HEARST GARDENS 
 DEVI DUTTA ARCHITECTURE

To: Leslie Mendez, City of Berkeley Planning & Development Department
From: Mark Rhoades, Rhoades Planning Group
Date: April 24, 2018
Re: 1155-1173 Hearst Avenue/ZP2016-0028 Response to April 5, 2018 Incomplete Letter

1155-1173 Hearst Avenue
Revised Applicant Statement
April 23, 2018

1 GROUND PLAN OPEN SPACE
 1/16" = 1'-0"

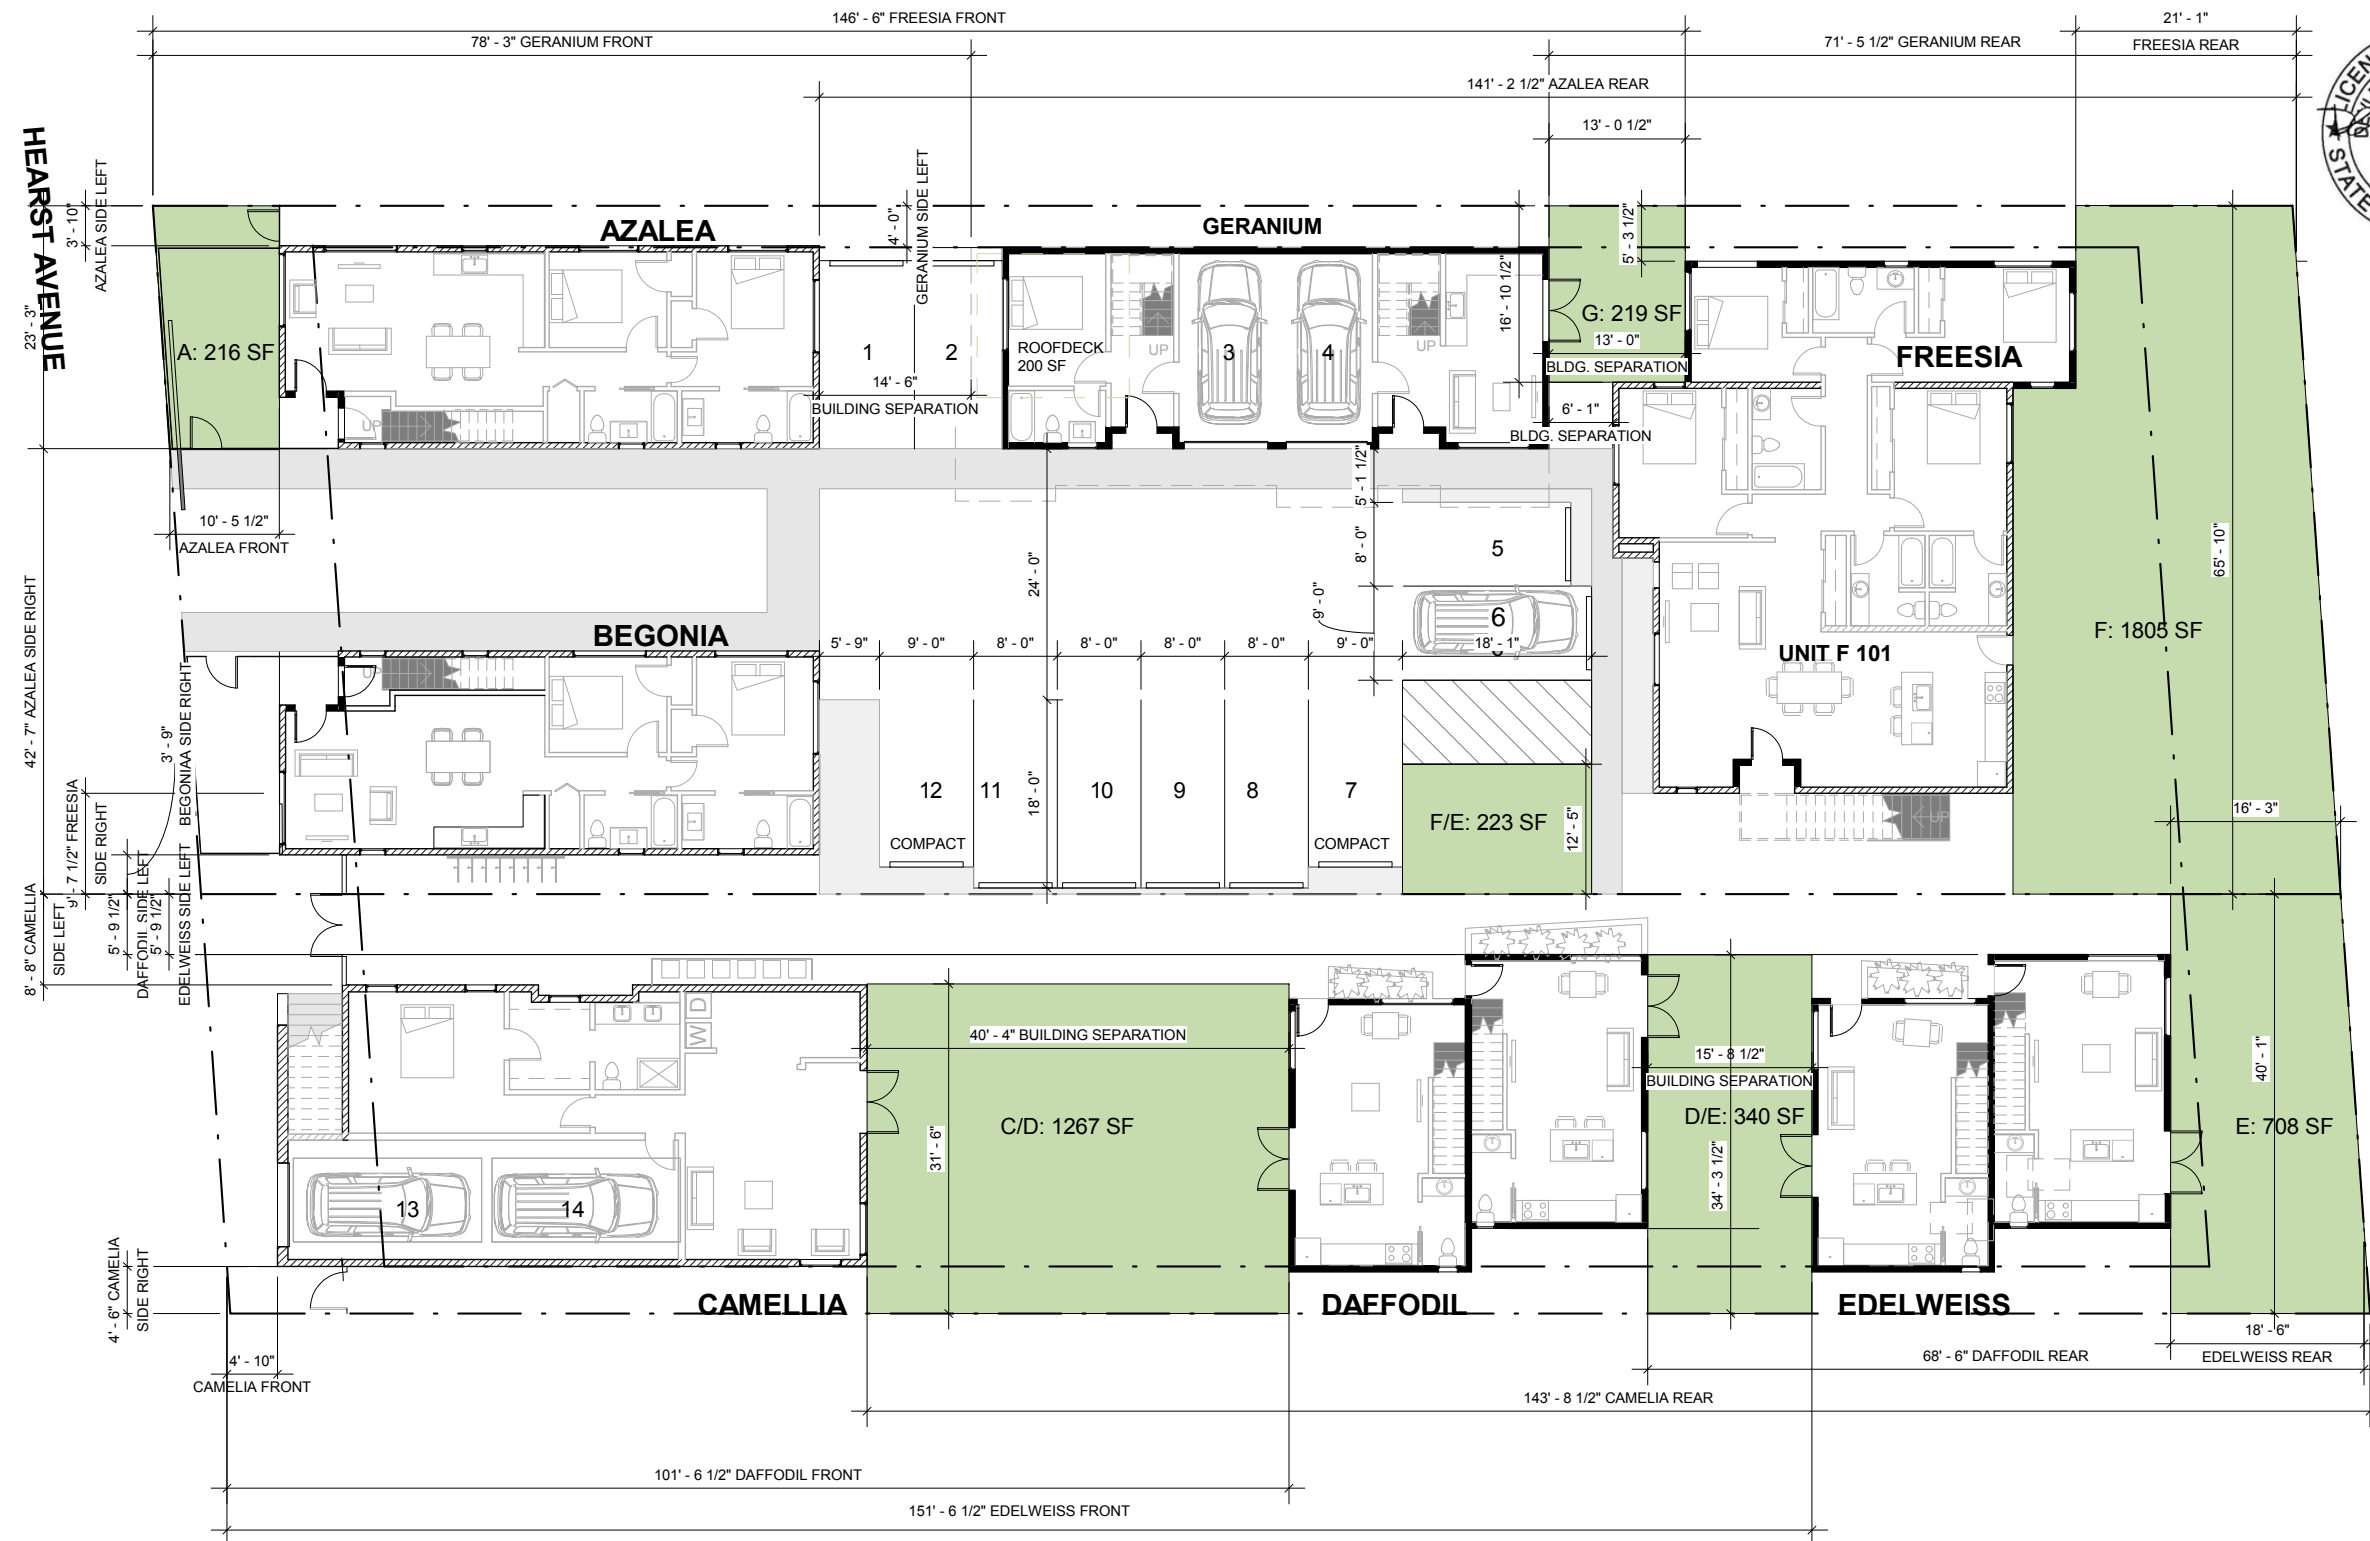
- The total Useable Open Space shown on A0.3 is 4,978 square feet, the zoning tables standards submitted as part of the applicant statement has 7,026 square feet, and the tabulation forms have a total of 4,715 square feet. Rectify.
- The gross floor area stated in the project plan set (16,006 sq. ft.), differs for the tabulation form total (15,795 sq. ft.), which differs from the applicant statement (15,480 sq. ft.)

- Legends – Each plan sheet that has color coding, different line types, hatching or other differentiation should have an accompanying legend. Although I think most have been covered, a few are missing, including the light grey shading on page A0.3 for example and the dashed lines mentioned in the bullet above.

Response: Please see Page A0.3 of the attached revised plan set, revised Tabulation forms and zoning standards table in the revised applicant statement for corrections.

Response: Please see Pages A0.3, A1.4-1.6 of the attached revised plan set for updated legends.

Response: Please see Page A0.3 in the attached revised plan set for useable open space diagram and table.

A1.5

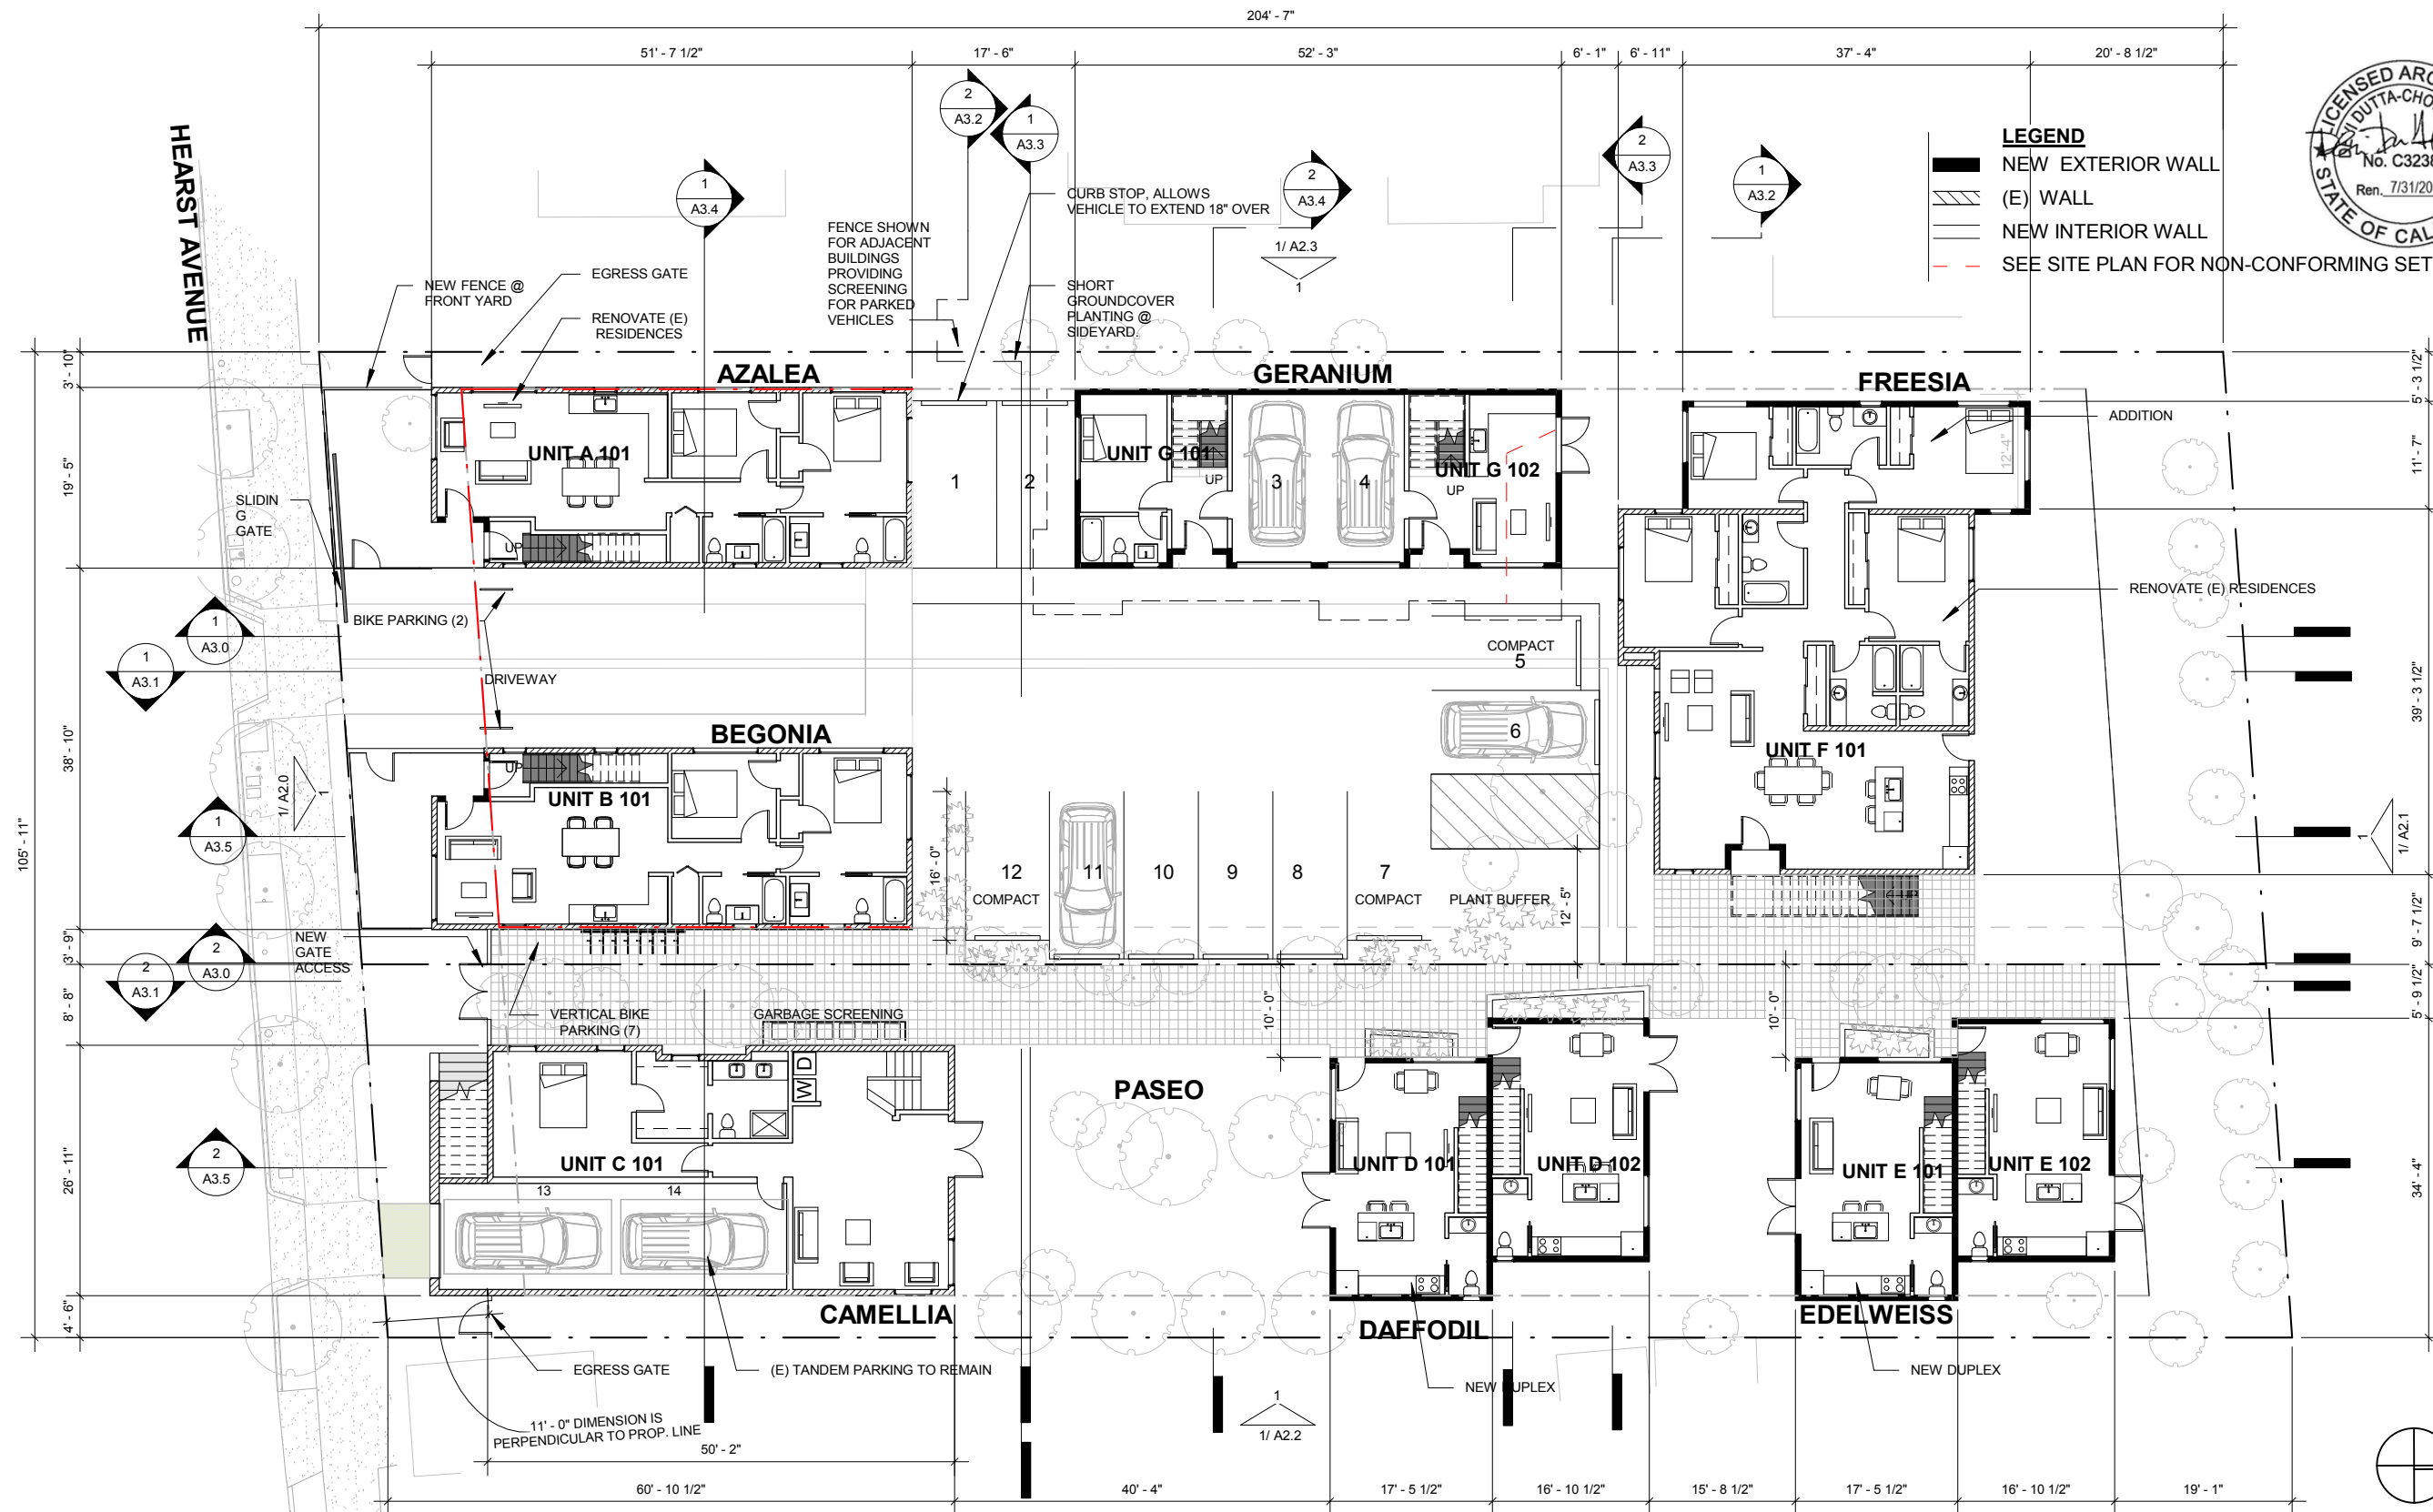
- Daffodil and Edelweiss have different northern entry doors with awnings on page A1.5 but are represented with the same floor plans and elevations on pages A4.2-A4.2 B. Revise the former, or present different floor plans and elevations.

Response: *Please see Page A1.5 in the attached revised plan set for correct placement of northern entry doors.*

Comments from City of Berkeley Traffic Engineer

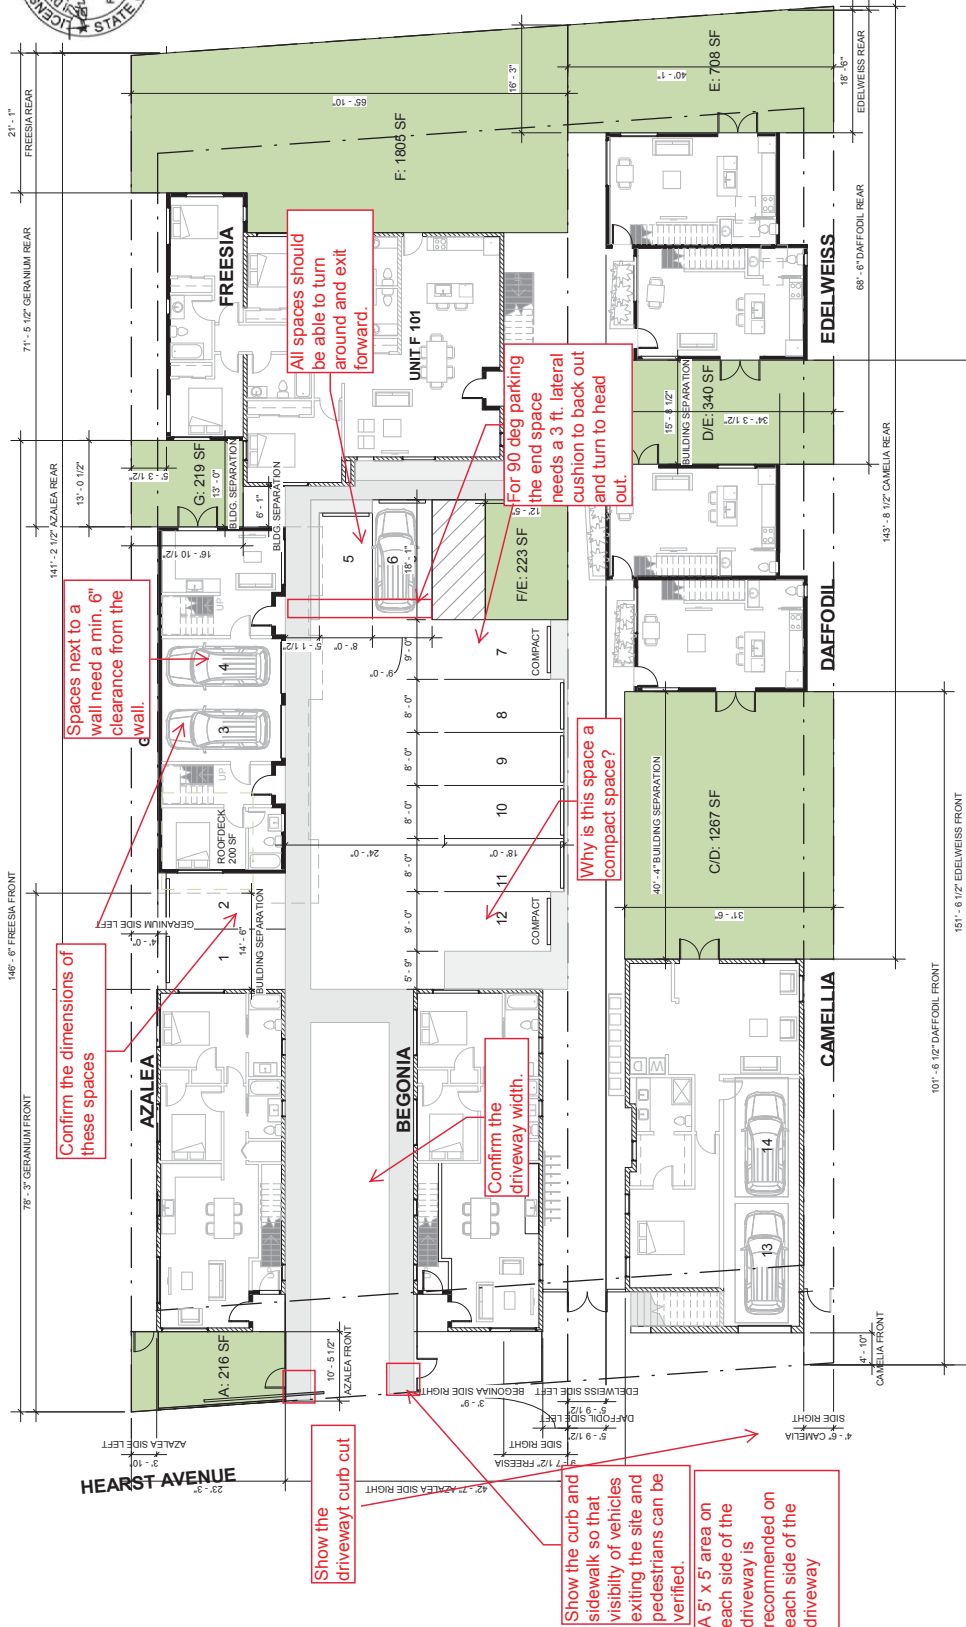
- Parking – The Traffic Engineer has reviewed the proposed parking layout and cannot approve it as currently proposed. I have attached the plan with his initial comments. Part of the difficulty in reviewing the parking plan is that there is no plan sheet that fully dimensions all spaces. Either revise A0.3 to dimension all parking spaces, driveways and turn around areas (length and width) or provide a separate plan sheet that does so. Also do not include the tandem space in Camellia as part of the parking plan.

Response: *The City's traffic engineer approved the parking plan via email on May 31, 2018. Please see Page A0.3 of the attached revised plan set for the parking plan with the requested dimensions.*
